Access Report

**Integrated Medical Offices &
Specialist Disability
Accommodation**

60, 62 & 64 Showground Road
GOSFORD NSW

For: CHP Fund
Ref: LP_22244

Figure 2 | Overall Site Plan

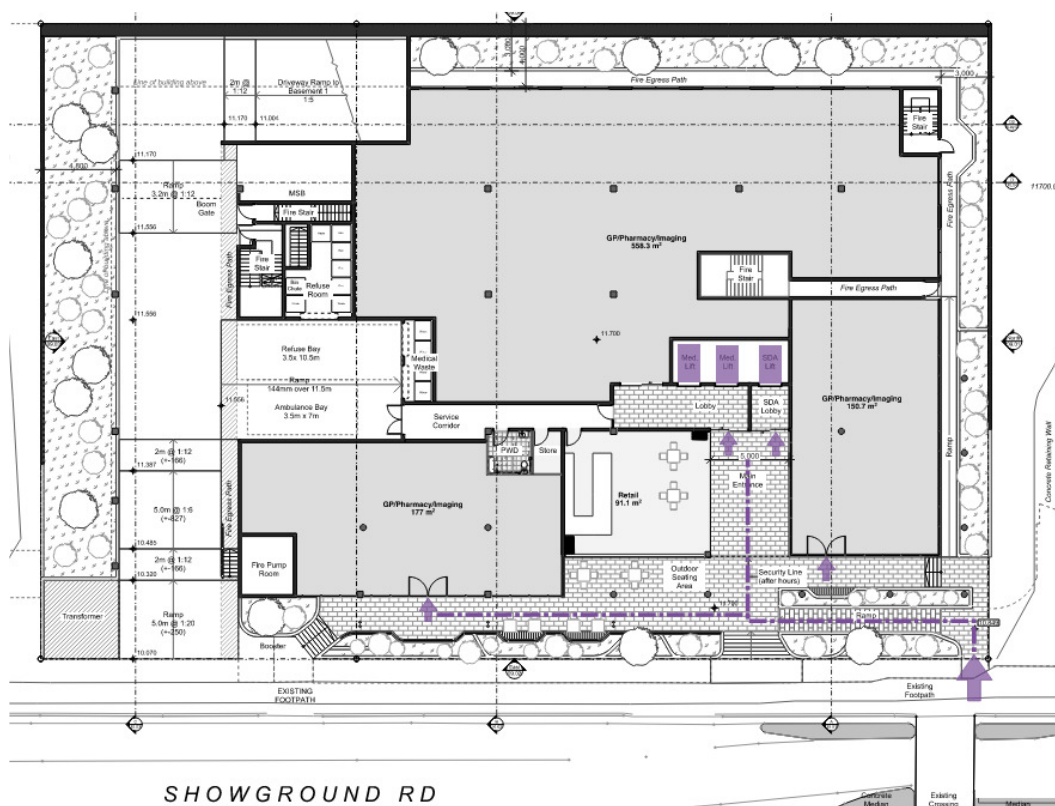
It appears the ramp has a gradient of 1:12 (851mm rise over 10.3m. This does not meet AS1428.1 in terms of gradient (1:14 max) or length between landings (9m).

The bottom riser is located at the property boundary. AS1428.1 requires 900mm set-back from the property boundary to enable the installation of handrail extensions and tactile indicators within the site.

Stairs will require handrails with extensions both sides, tactile indicators top and bottom and contrasting non-slip nosings to treads.

Ensure the provision of extensions to the handrails; contrasting non-slip nosing strips to treads; and tactile indicators top and bottom of each stair.
